29 June 2015

RE: DEVELOPMENT APPLICATION REF:LDA 2015/0032, SHEPHERDS BAY STAGES 6 AND 7, ADDRESS: 37-53 NANCARROW AVENUE, RYDE

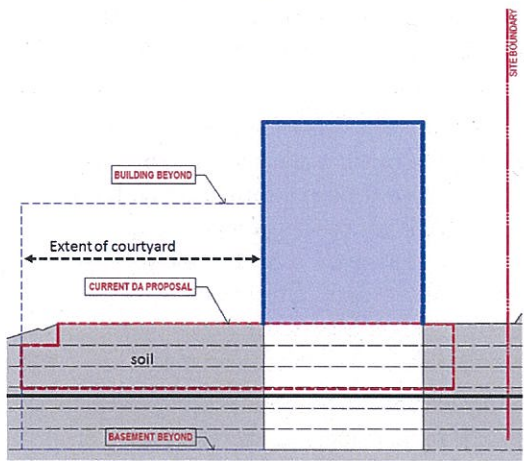
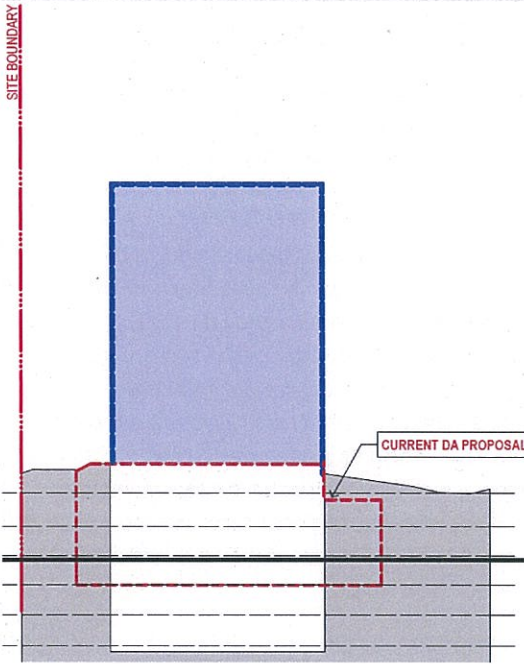
d) Drainage In regards to the proposed stormwater management system and public drainage infrastructure traversing the property; - The design drawings for the proposed new public drainage line traversing the property show the flow velocity in the pipe will exceed 11 m/s in certain sections which exceeds the Council's maximum rate, specified in Section 5.3. 1 of the DCP Part 8.2 (Stormwater Management). Further to the concerns raised for Stages 8 & 9 regarding the manner of discharge to the Harbour and potential scouring impacts, the nominated flow rate and capacity of the proposed public drainage system is such to cause rapid degradation of the asset which can significantly reduce its serviceable lifespan. Accordingly the system must be redesigned to ensure the conveyance of stormwater runoff from the greater upstream catchment and roadway related areas is of a rate and capacity complying with Council's DCP requirements. To this end, the following is required; - The proposed public drainage system should be redesigned by reducing the capacity of the inground drainage infrastructure to a lesser event (20yr ARI) and making provision for a	- BG&E met with Council on 4 June 2015 and have a comprehensive understanding of Council's preferred design approach. - BG&E are currently preparing an amended stormwater design to the satisfaction of Council. - BG&E will confirm in early July that an amended stormwater solution can be achieved without the need to alter the floor levels of the buildings. - On this basis, it is proposed that a deferred commencement condition be imposed requiring final resolution of the stormwater design through the site to Council's satisfaction prior to activation of the consent. - BG&E are currently in the process of producing the supporting calculations/report including the water quality model (MUSIC) in relation to the Bioretention System and Gross Pollutant Trap. - Turner Architects are in the process of reviewing and amending where necessary basement threshold levels in consultation with BG&E and an amended architectural package incorporating these amendments will be provided in early July 2015. - Landscape design plans and details will be amended in accordance with the engineers solution above and again it is considered

Council Issue	Response
defined overland flow path able to convey runoff during the 100yr event (accounting for 30% blockage of the inlet capacity of the inground infrastructure). • A revised HGL analysis must be provided for the inground drainage infrastructure. All design assumptions or relevant parameters are to be noted on the plan. The details must comply with the requirements specified in Section 5 of the DCP Part 8.2 (Stormwater Management), particularly Section 5.3.1 in regards to pipe velocities. • A defined overland flow path is to be provided through the site. The design is to convey overland flow resulting from the 100yr event accounting for 30% blockage of the inground drainage infrastructure. The velocity-depth product must comply with Section 5.4 of the aforementioned DCP Part. Details demonstrating this must be submitted. • The overland flow path and development's WSUD measures (creek beds) are to be separated, to ensure major stormwater runoff from upstream areas will not enter, damage or degrade these components, which are to be maintained by the owners of the future development. • The downstream impacts and flows over public areas are to be considered with respect to property damage and public safety. • Copies of the DRAIN and HECRAS/ TUFLOW modelling to clarify the design. • The applicant is to provide modelling to demonstrate that the design (and specifically the inlet arrangement upstream of Constitution Rd) does not increase flooding or risks. • The applicant will need to provide a design of a major system component to satisfy the Floodplain Development Manual (FDM) requirements for the types of use/risk of the location as a park. • Referring to Harris Page and Associates Stormwater Plan (C-0200 to C- 0291 dated 23 December 2014), a Bioretention System and Gross Pollutant Trap is proposed. The supporting calculations/ report including the water quality model (MUSIC) shall be submitted to the Council for review.	appropriate and reasonable for the issue of landscape design through the centre of the site be dealt with as a deferred commencement condition of consent subject to the resolution of the final stormwater design to Council's satisfaction.

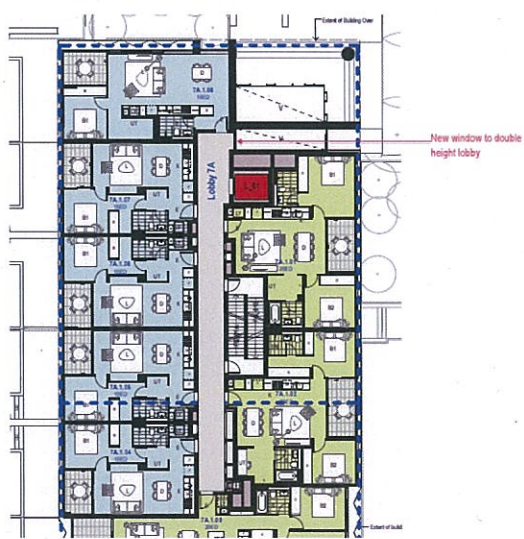
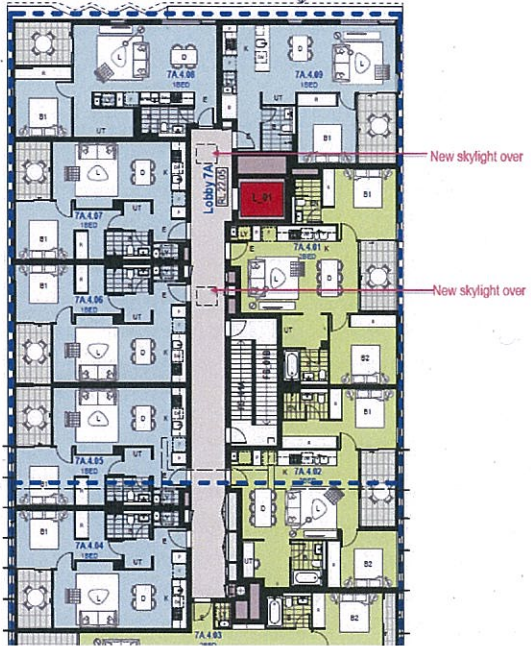
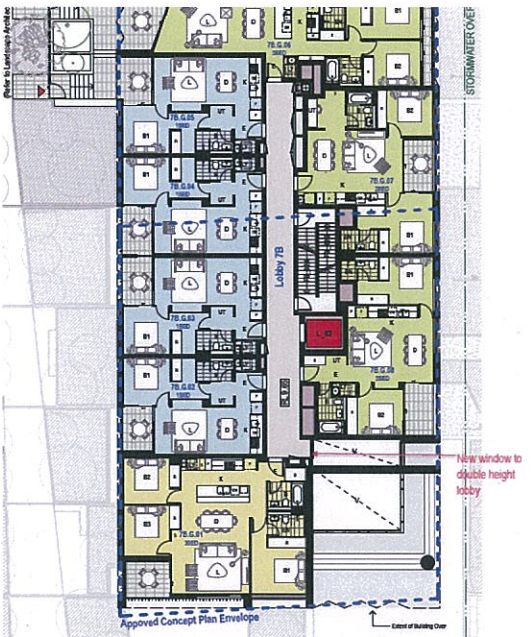
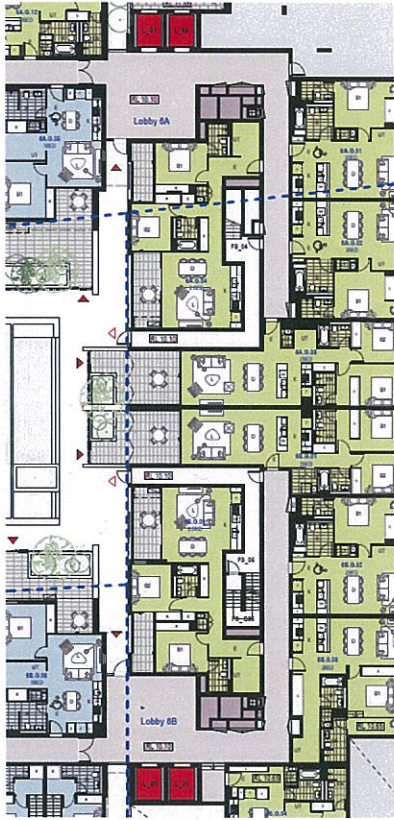
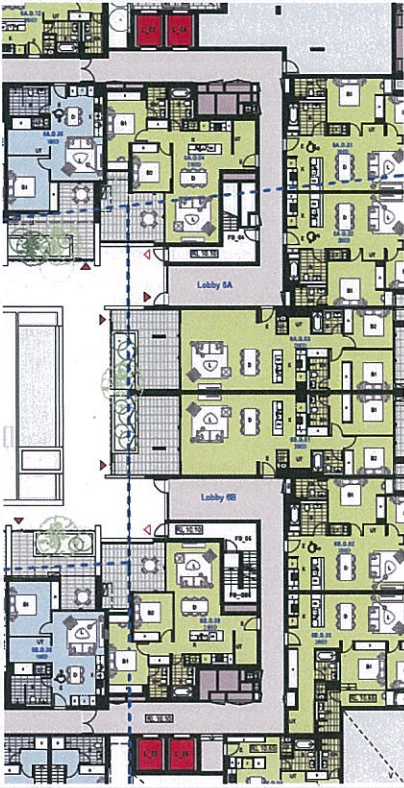
b) Basement footprints Condition No.4 of the modified concept approval requires: "Future Development Applications shall ensure that basement parking levels do not exceed 1 metre above ground level (finished) and are located below the building footprint (with the exception of basements connecting Stages 2 and 3 and Stages 4 and 5) without encroachment into street setback areas." Concerns are raised that the proposed basement areas extend beyond the building footprint	Due to the narrow footprints of the two proposed buildings in Stages 6 and 7, an interpretation of Concept Plan consent Condition No. 4 to require basements only under the buildings above would result in extremely inefficient basement layouts with the inevitable result being the need to increase from 3 to 6 basement levels and additional excavation and dewatering and general disturbance of the site. The basement design for Stage 7 would be especially poor because the ramping would occupy the majority of each basement level, and this could only be alleviated with the use of car lifts, which is also a poor and unnecessary outcome.

Council Issue	Response
underneath the communal garden area of Stage 6 and within the street setback areas of Stage 7. As such detailed justification for the non-compliance including consideration of providing additional basement levels underneath the building footprint is required to be submitted.	Sketch plans are provided below which illustrate the ramifications of this approach.  Stage 6: Section illustration of proposed basement levels and implication of basements only below footprint.  Stage 7: Section illustration of proposed basement levels and implication of basements only below footprint.

Council Issue	Response
	 MINIMUM (B99 VEHICLE) TURNING CIRCLE, ALL TURNING PATHS SUBJECT TO TRAFFIC ENGINEER REVIEW CORES ENCROACH ON AISLES. (IF CORES OFFSET TO SUIT CAR PARK, THEY WILL BLOCK CORRIDORS ABOVE) BUILDING ENVELOPE ABOVE 2 WAY RAMPING AISLES REQUIRED (TO GET TO/ FROM ENTRY), 5.8m WIDE PLUS CLEARANCES TO STRUCTURES AISLES TAKE UP 58% OF CAR PARK FLOOR CORES ENCROACH ON AISLES. (IF CORES OFFSET TO SUIT CAR PARK, THEY WILL BLOCK CORRIDORS ABOVE) CAR SPACES WILL REDUCE FURTHER FOR PLANT, STORES, BICYCLE PARKING, ETC TYPICAL FLOOR < 28 SPACES PER FLOOR Stage 7: Illustration of the required extent of ramping for a basement level contained only under the building footprint which occupies the majority of each basement level The core objective for locating basements only under building footprints is to ensure that sufficient deep soil is provided on site, which was central to the Planning Assessment Commission's consideration of the issue for Stages 2, 3, 4 and 5. In this instance, the proposed basement arrangement still results in 52.86% of the open space and 25.8% of the site as being deep soil. This is profoundly in excess of the minimum requirements of the Residential Flat Design Code which requires 25% of the open space to be provided as deep soil and 6.25% of the site to be provided as deep soil (based on minimum common open space area of 25% of site). It is also well in excess of the 7% deep soil required under the new Apartment Design Guide which will replace the Residential Flat Design Code. In other words, the proposed development provides deep soil which is 200% of the minimum required

Council Issue	Response
	amount of the common open space area and <u>456%</u> of the minimum required amount of the site which must be deep soil. Given the substantial provision of deep soil which is still capable of being provided on the site with the proposed basement arrangement, there is no reasonable basis for concern in relation to the proposed basement arrangement and amendment of the basements would be unreasonable as it would not serve any planning purpose and would simply result in basement inefficiencies and double the number of basement levels. Moreover, the wording of the condition is primarily aimed at preventing encroachment into street setback areas only. The basements as designed and as shown in the DA drawings do <u>not</u> encroach into any street setback areas. It is therefore considered that the design as shown in the current DA documents complies with Concept Plan consent condition No. 4.
